Discretionary Review Abbreviated Analysis

Date: June 18, 2020
Case No.: 2018-001662DRP
Project Address: 2476 Diamond Street
Permit Application: 2019.1205.8713
Zoning: RH-1 [Residential House- One Family]
40-X Height and Bulk District
Block/Lot: 6700 / 032
Project Sponsor: Jeremy Schaub
Schaub Ly Architects
1360 9th Avenue, Suite 210
San Francisco, CA 94122
Staff Contact: David Winslow – (415) 575-9159
David.Winslow@sfgov.org
Recommendation: **Take DR and Approve as Modified**

The project proposes to correct an approved building permit application number 2019.1015.4489 with BPA 2019.1205.8713 to correct the retaining wall and grade heights to be in conformance with Code Section 136, which allows up to 3' of additional height in grade above existing grade and retaining walls to be no more than minimum required guardrail height (42").

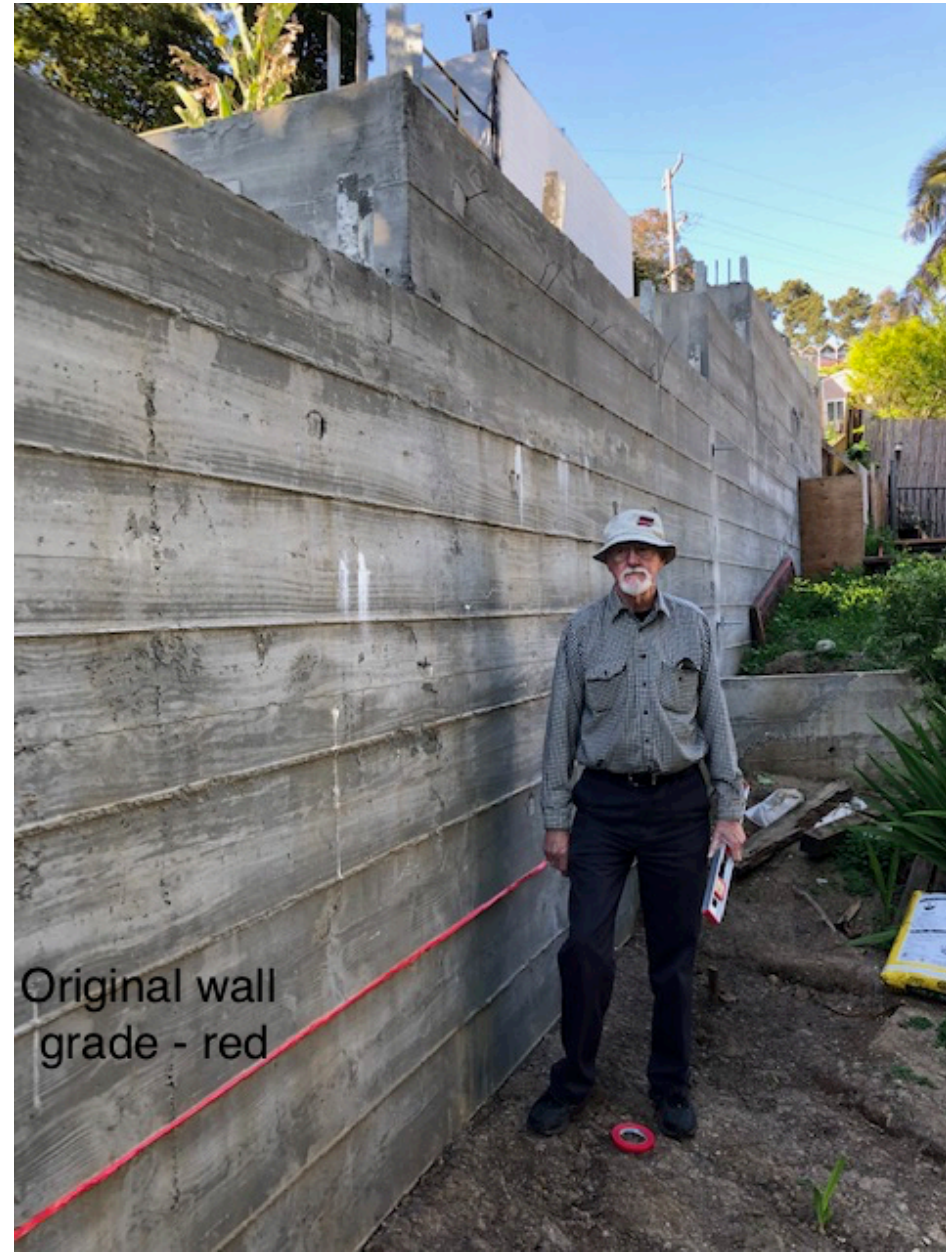
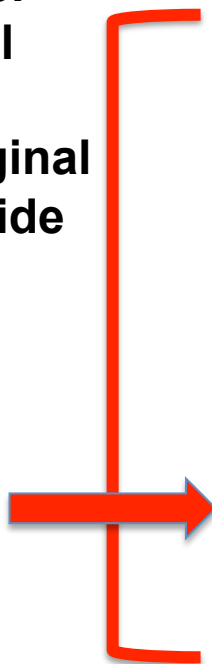
- Red line denotes original grade of wall at ~350ft.
- Each form line across retaining wall is ~1ft in height
- Height of owner Tim Tidol (>6ft) !
- Original retaining wall height ~1.7ft high
- Retaining wall impacts across 3 properties:

- ~10ft. of sheer concrete wall
- ~6ft over original grade of hillside

Site Photos of 2476 Diamond St. Retaining Wall: 30 Arbor St. Perspective

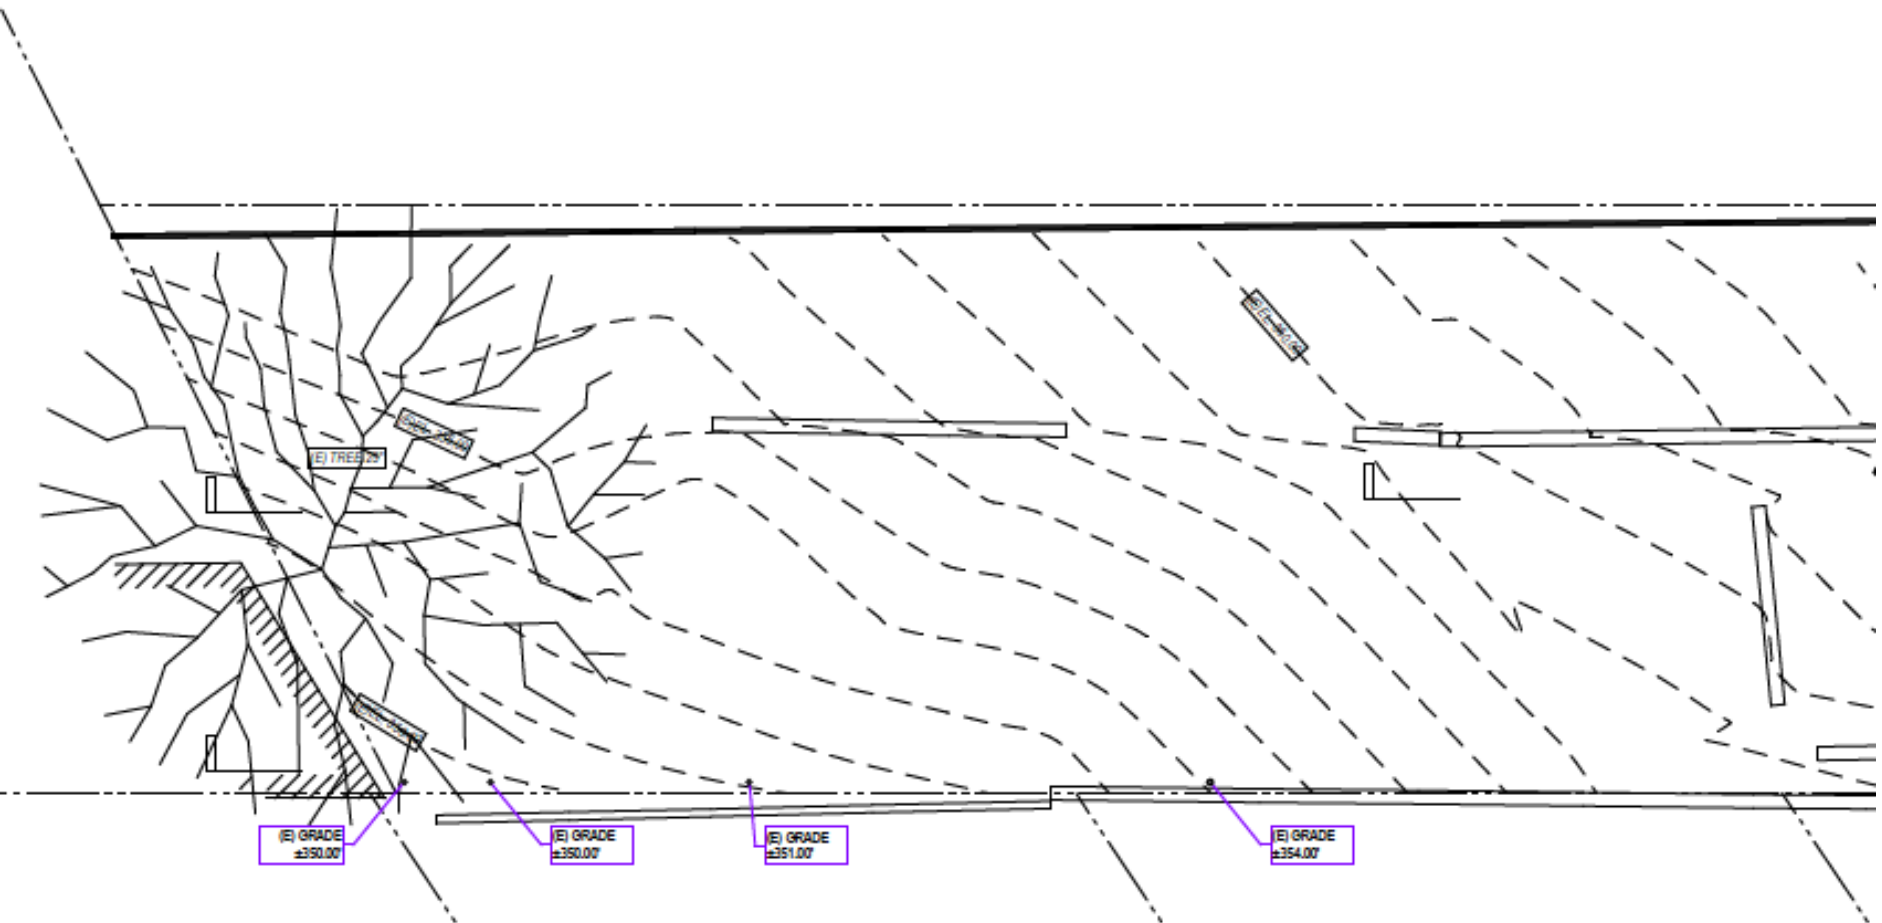
To Note:

- Original retaining wall (350.5ft) and ground grade (350.0ft)
- Original grade of 2518 Diamond St. measured at 248.3ft.
- Retaining wall height was ~1.7ft high
- For scale, sitting bench at 2018
- Diamond in view

2476 Diamond St. Rear Yard – Original

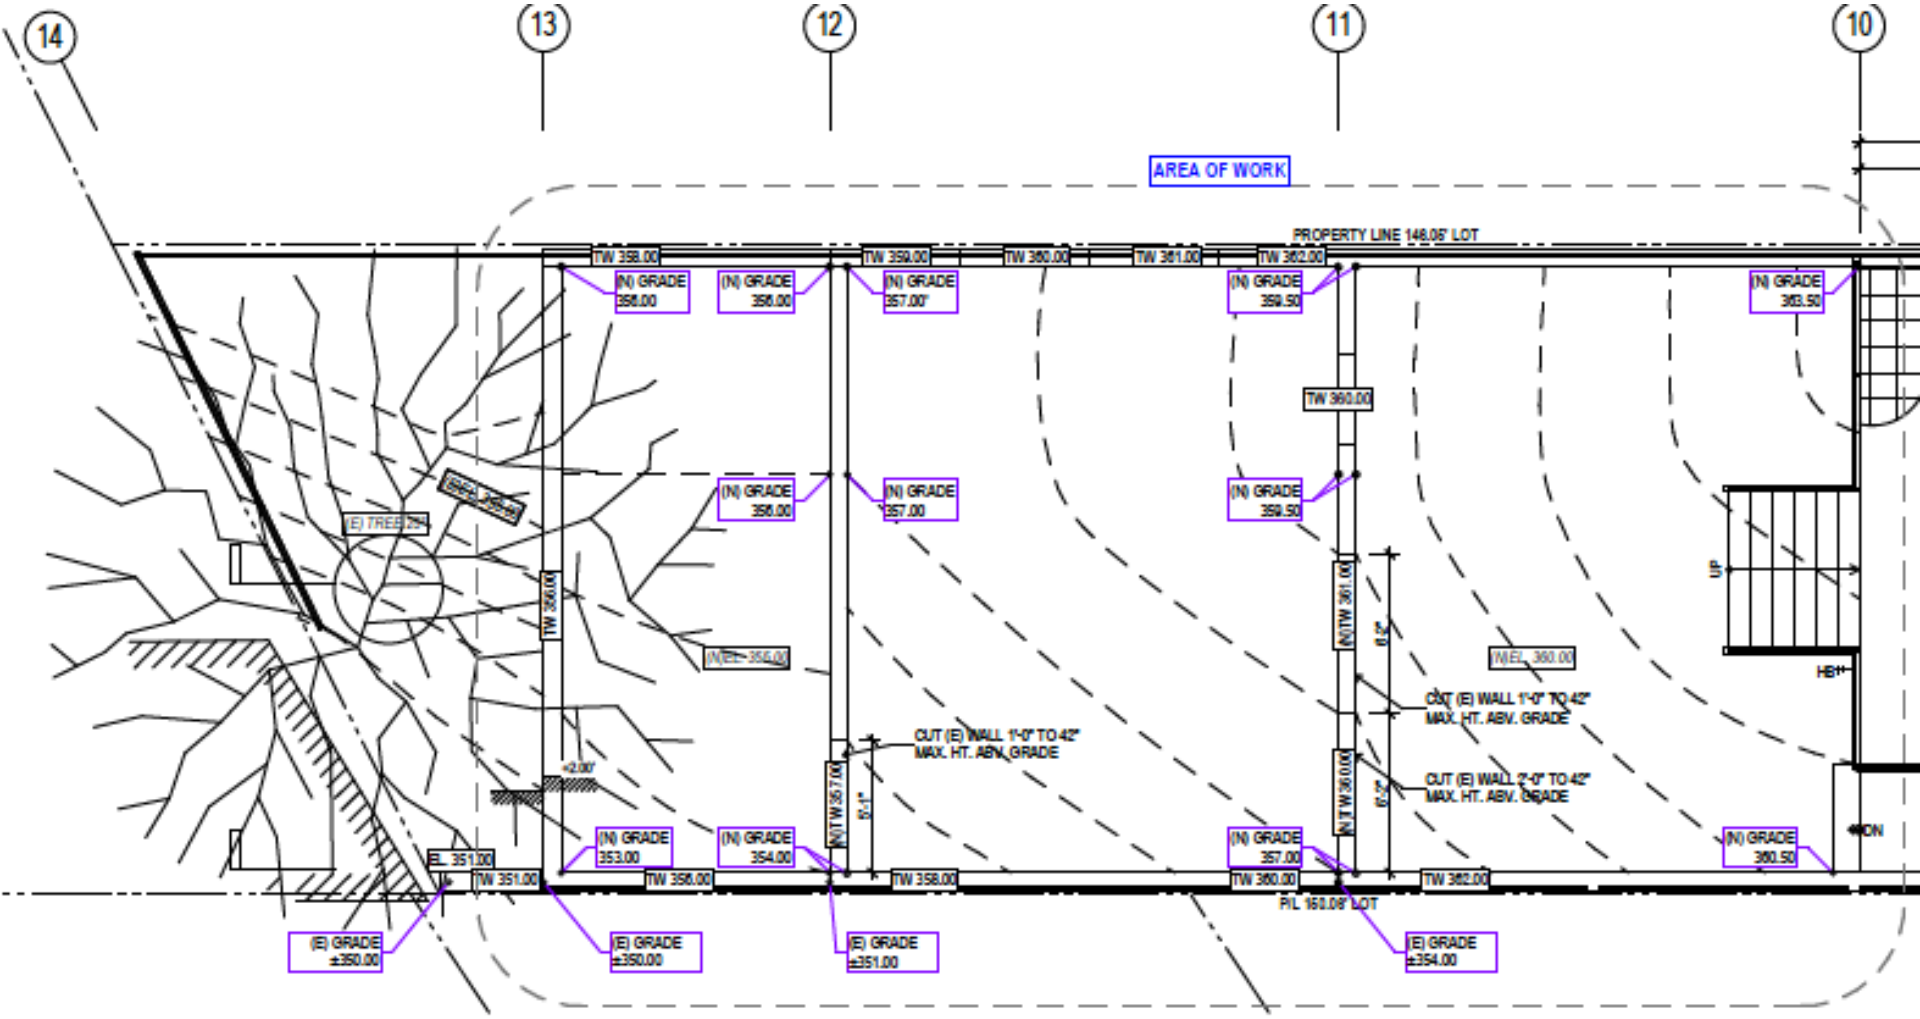
2d. The proposed plans do not respect the existing sloping topography of the hillside shared by neighbors. The plans attempt to elevate and terrace almost the entire rear yard from it's highest elevations with an "earthen deck" that rises above the natural sloping grade of the hill. This attempt to increase the height of the natural grade -in affect building a hill above all surrounding rear yards- places a burden on all the surrounding neighbors. Direct sightlines from the elevated yard into the interior living spaces and yards of 5 neighbors would be the result of the proposal.

- 3b. Any grade change that increases the height of the yard in relation to the surrounding properties should be reduced to historic levels in order to maintain neighbors access to the mid-block open space, protect sensitive site lines, and minimize impacts from light and noise.

- 3c. If the developer desires a level grade across the yard & patio spaces, then a height limited to the lowest original grade of the hillside should be used (or lower than the original grade). A lower grade could provide all the benefits of a level space without the burden of impacts being place on the neighbors.

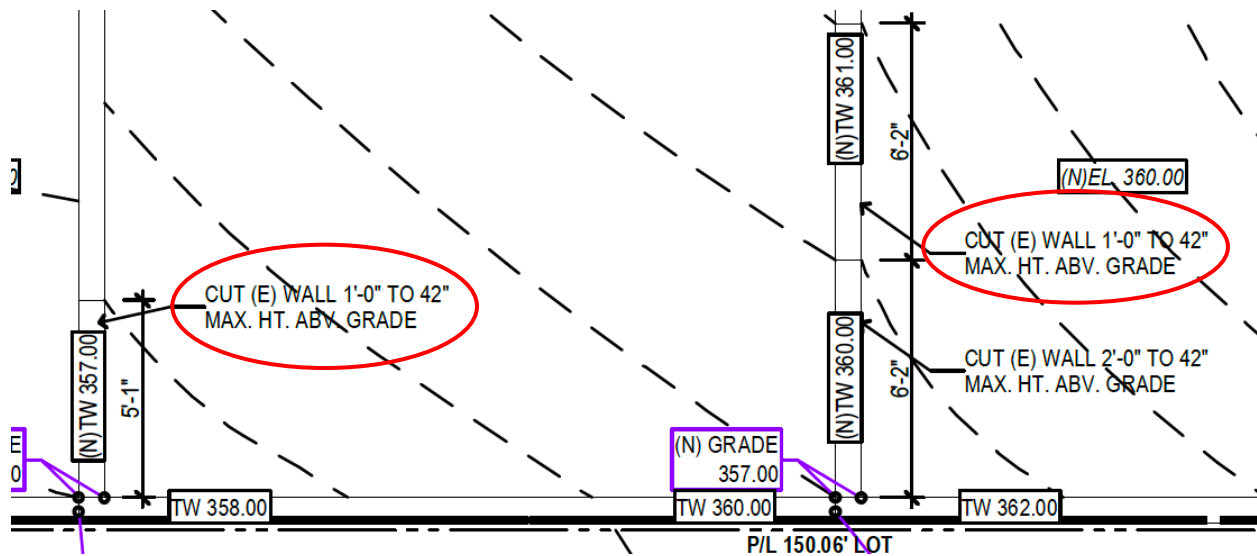
The Subject Permit proposes to lower the height of the cross-lot retaining walls by 1-2 feet, as noted on the site plan:

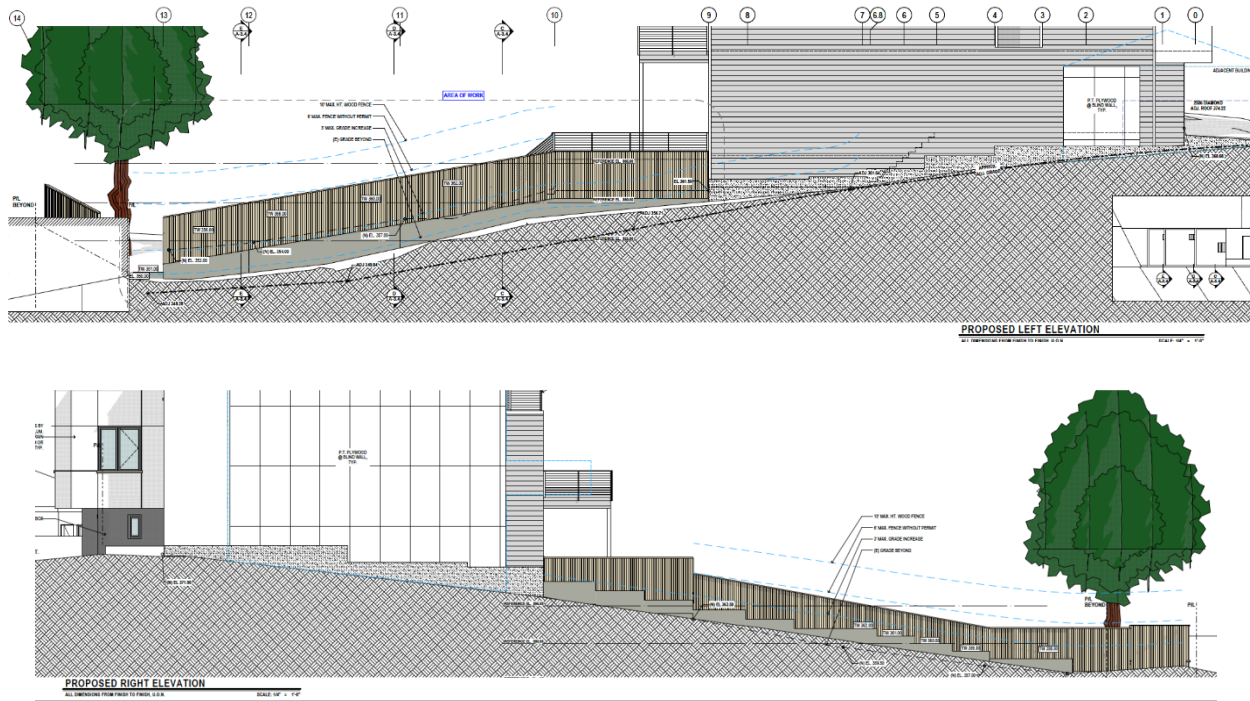
As discussed in the DR request, the DR requesters' actual objections relate to the height of the *boundary* retaining walls, which have already been approved and constructed pursuant to BPA Nos. 201801239223 and 201910154489. Even if the boundary walls fell within the scope of

Although the boundary retaining walls and fences are already approved, and are beyond the scope of this DR request, the Project Sponsor wants to work his neighbors on this issue. The Project Sponsor has offered to reduce the existing fence-wall height and make it follow the sloping topography smoothly rather than stepping down the slope:
